FCC ID: HBW1D8088-1

IC: 2666A-1D8088

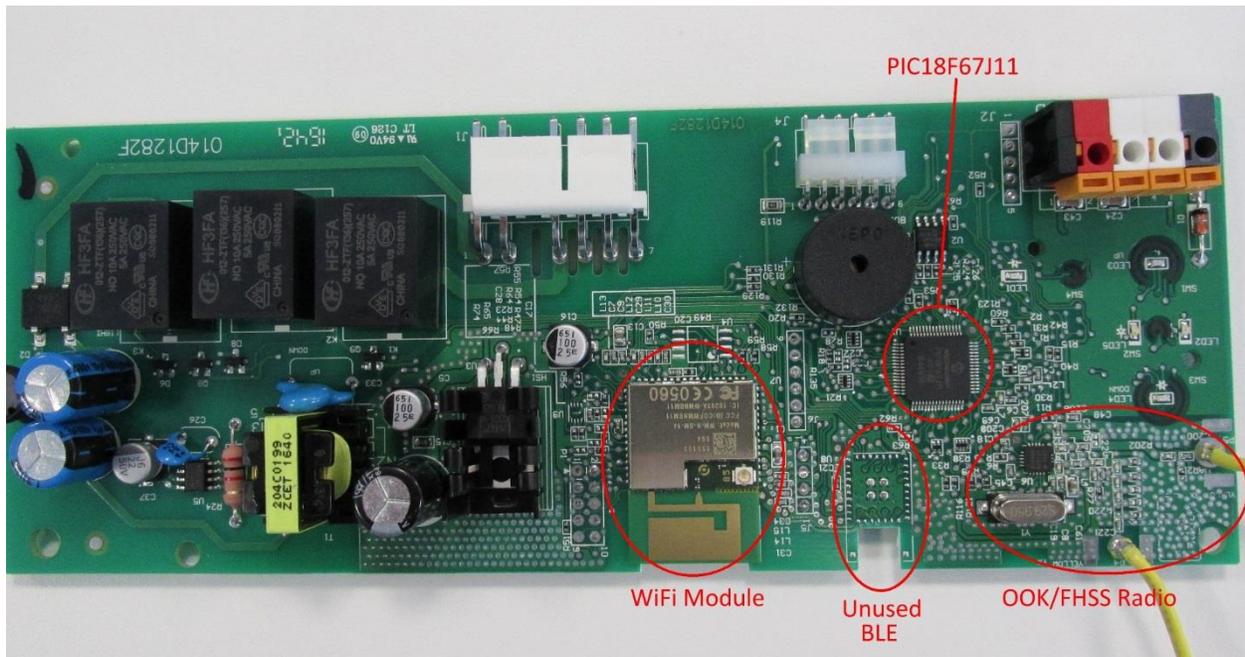
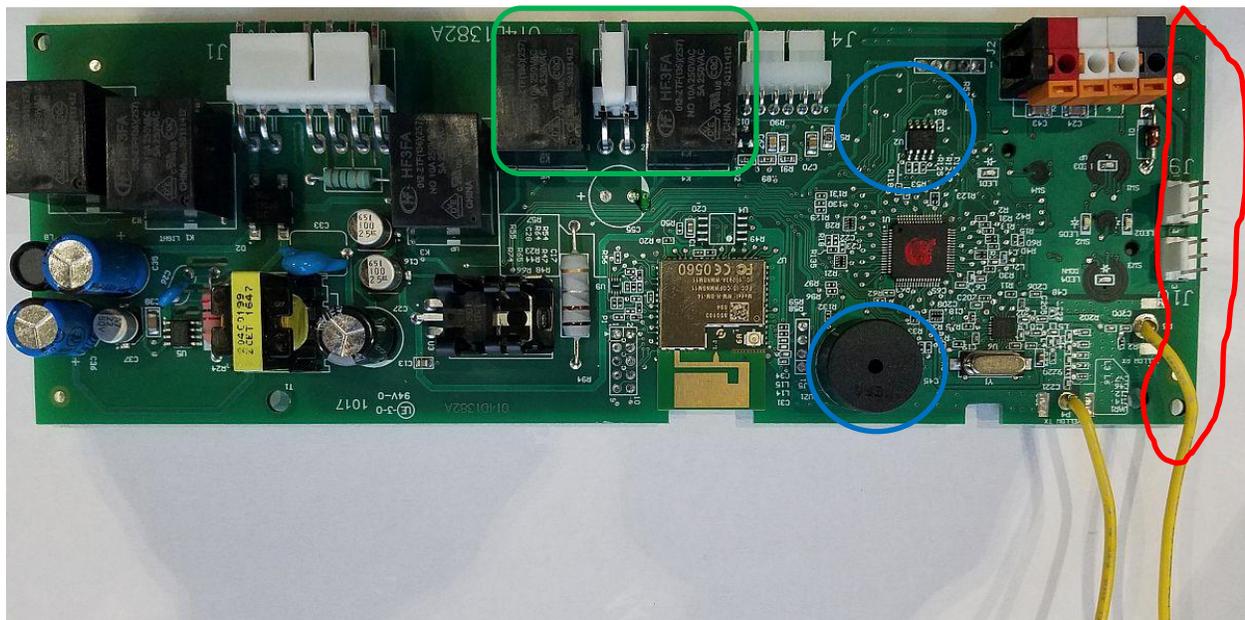
Circled in red is the area of the board added with the new PCB connectors.

Blue circles indicate current and original location of the speaker

Green indicates area where relays were added

A few components on the left side of the PCB were moved to optimize layout.

- The locations of the WiFi module, Microprocessor, Radio & antenna's, and User interface remained locked in place
